**Subject: Bid Package #2**  
Abbott Middle School HVAC Replcmt-DSA 01-119556  
George Hall Elementary School HVAC Replcmt-DSA 01 119523  
Laurel Elementary School HVAC Replcmt DSA 01-119551  
San Mateo - Foster City School District

### **ADDENDUM NO. 3**

San Mateo-Foster City School District  
HVAC Replacement Scope,  
Abbott MS DSA 01-119556  
George Hall ES DSA 01-119523  
Laurel ES DSA 01-119551

SHEET # AD3-  
A2.01

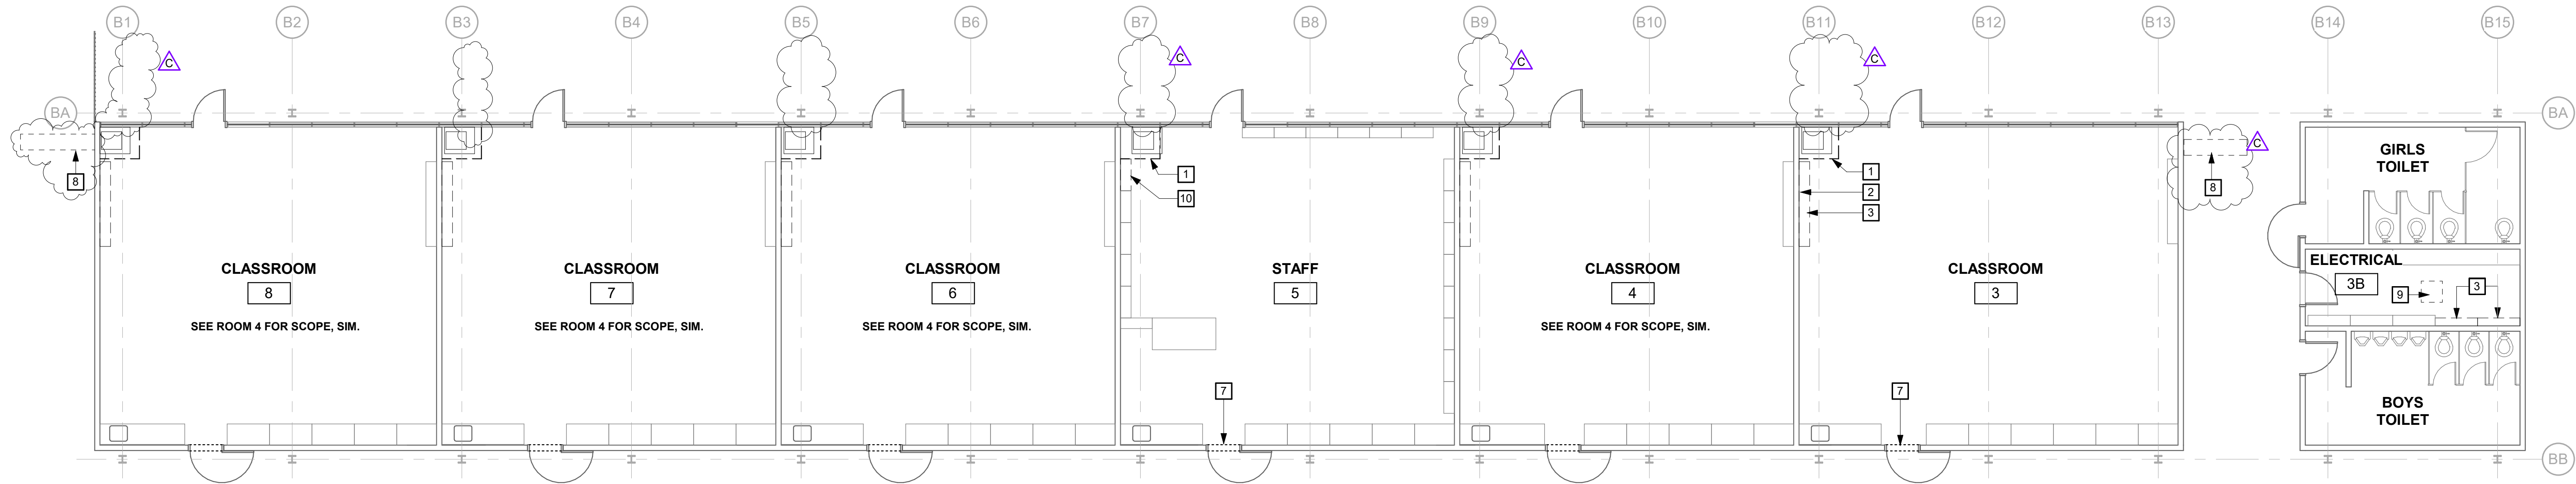
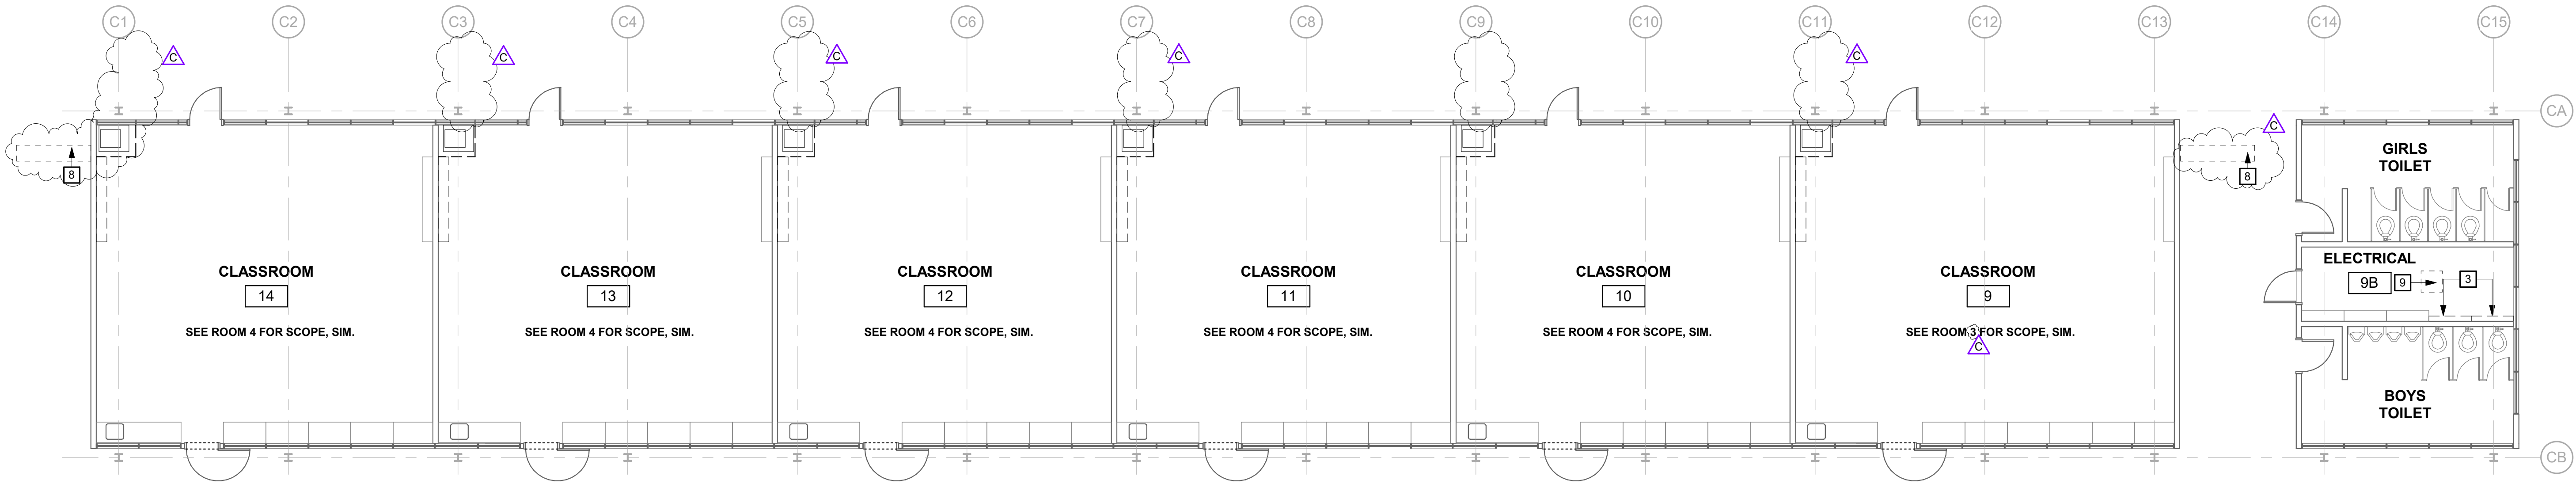
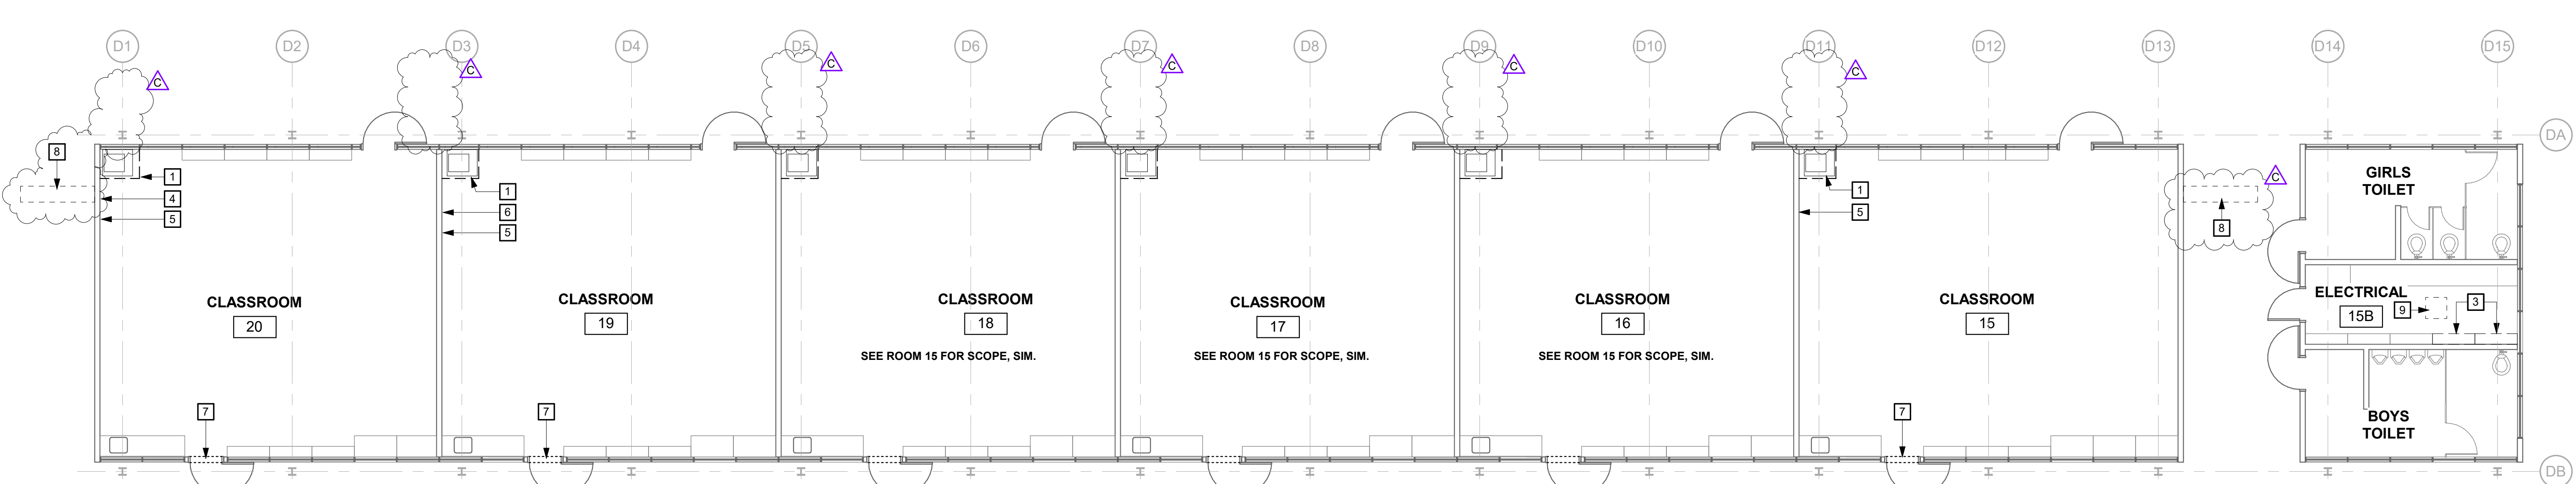
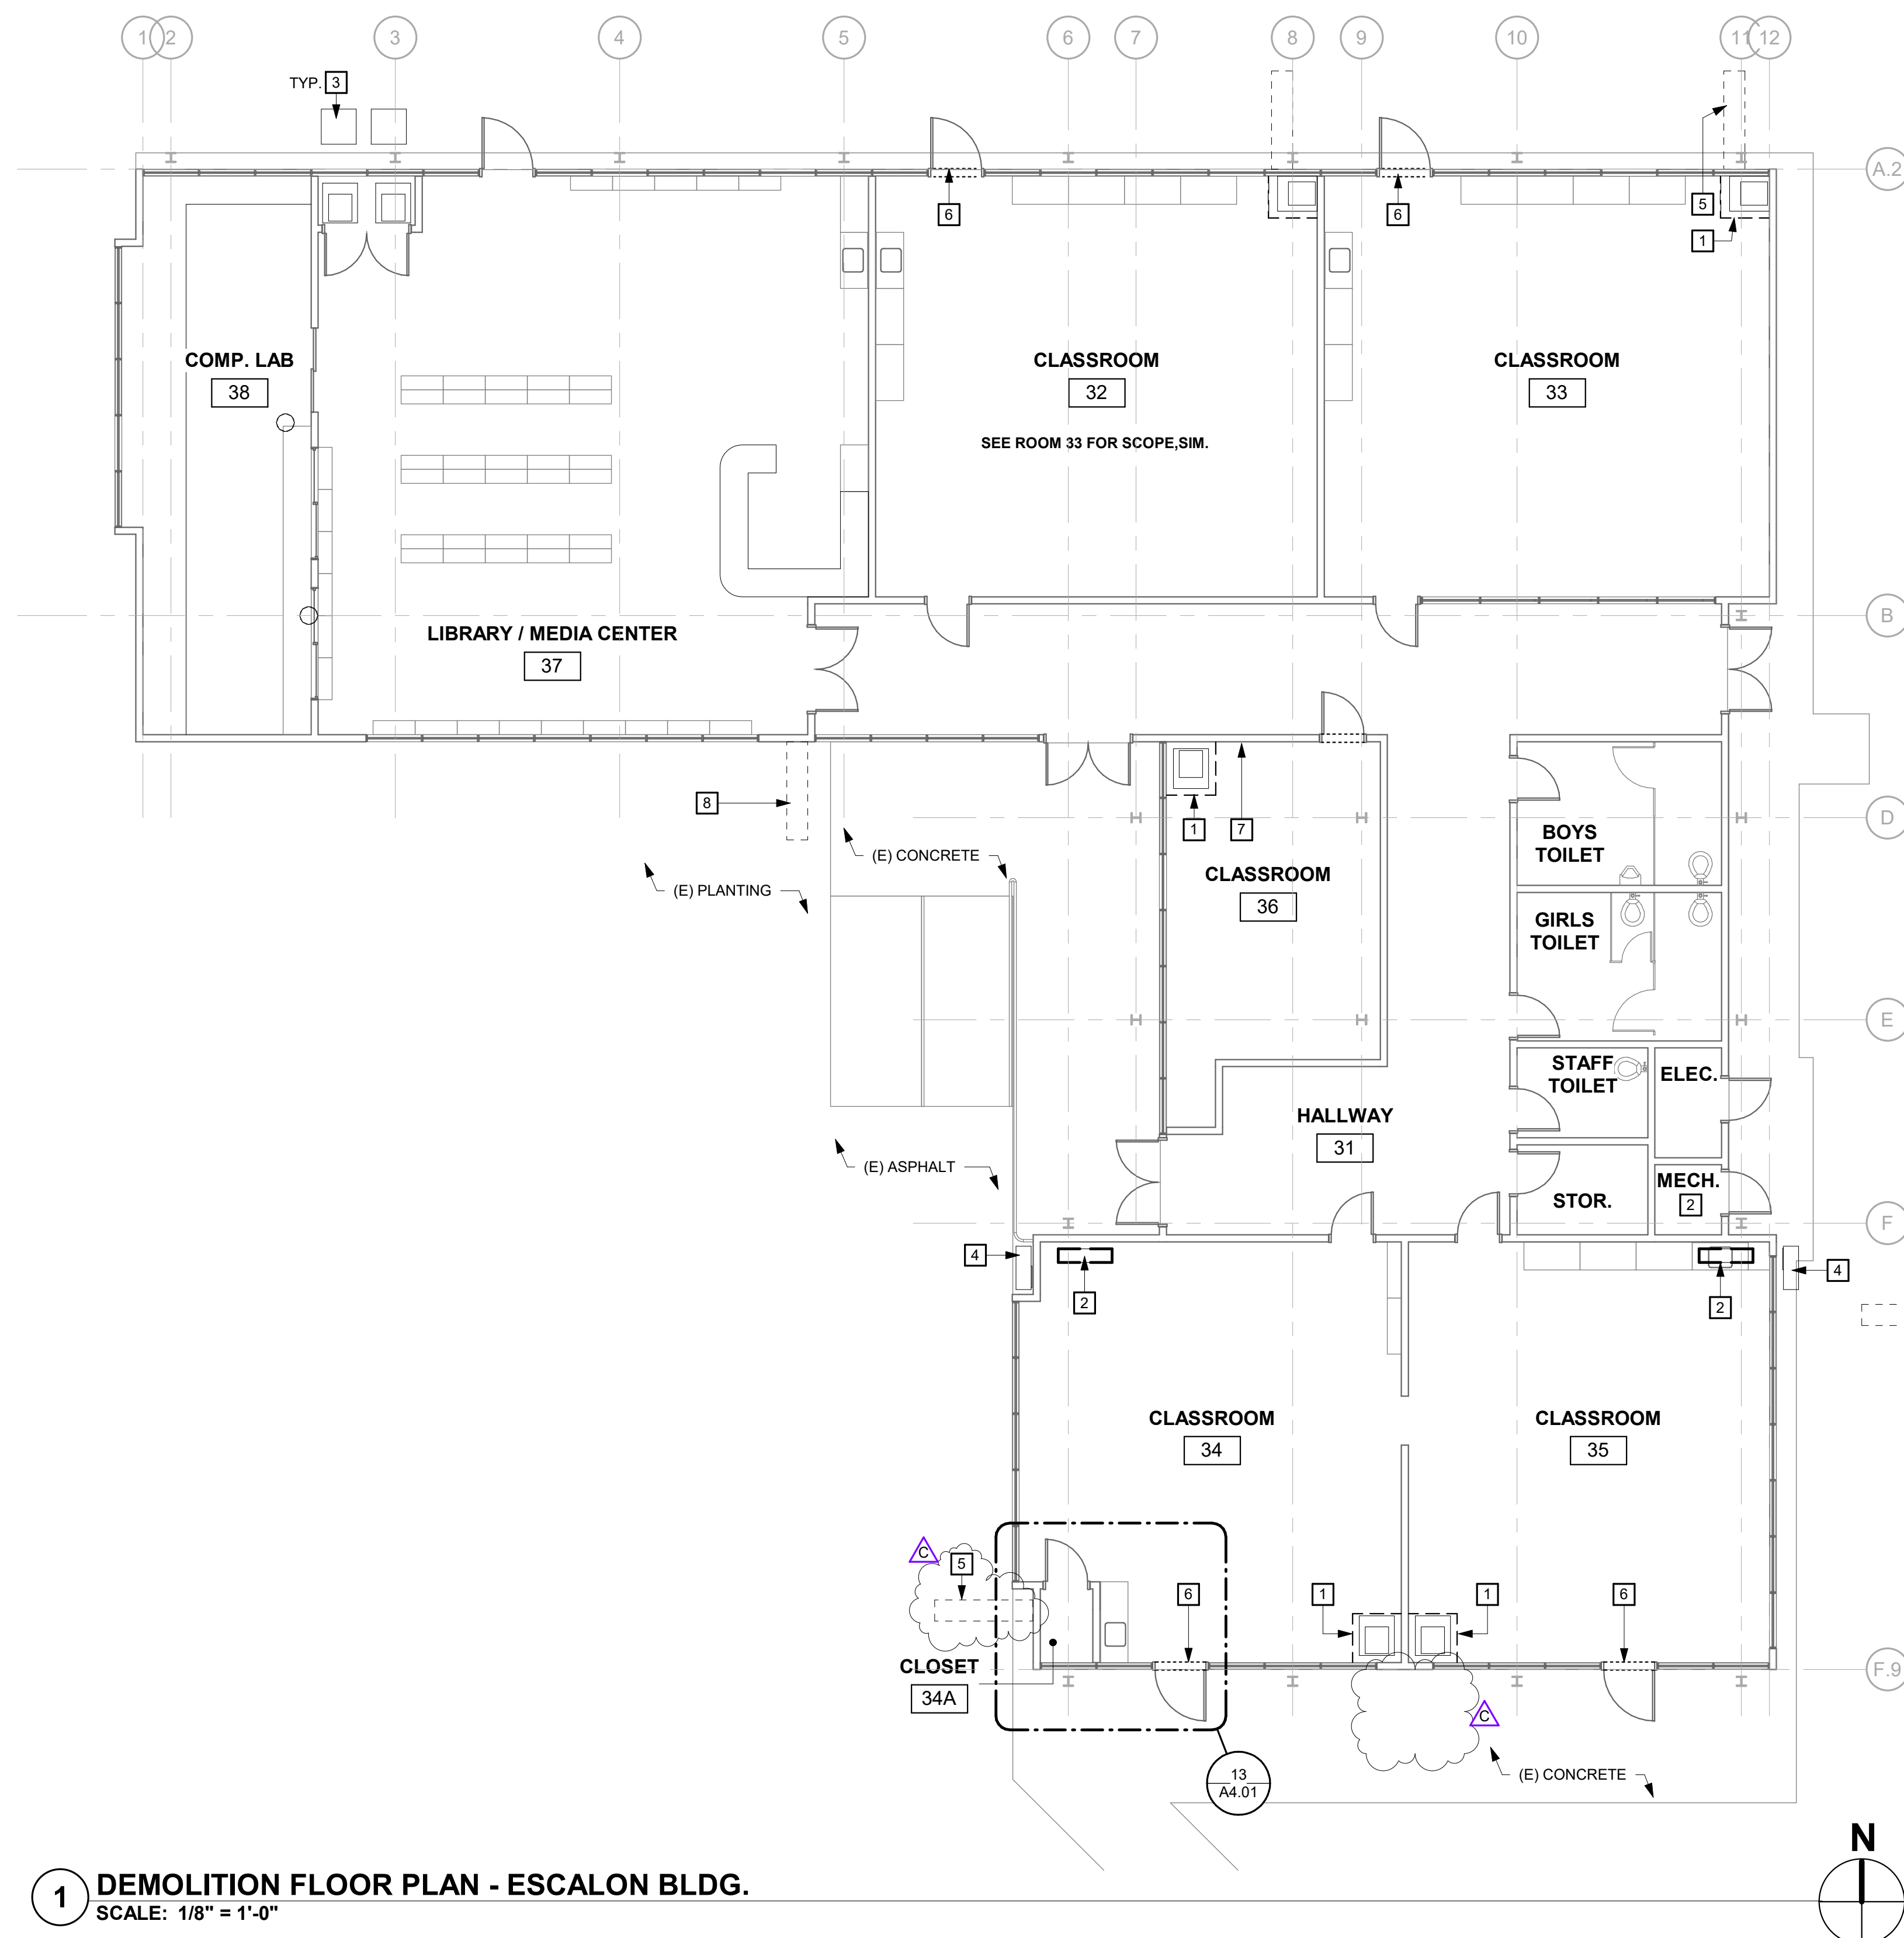
ITEM NO. 3.13:     DRAWING SHEET A2.01 – DEMOLITION FLOOR PLANS – WINGS 1, 2, 3, & 4

Revise: Demolition Floor Plan Keynote #1 per attached AD3-A2.01.

Revise: Demo and prep for drywell at locations indicated on attached AD3-A2.01.
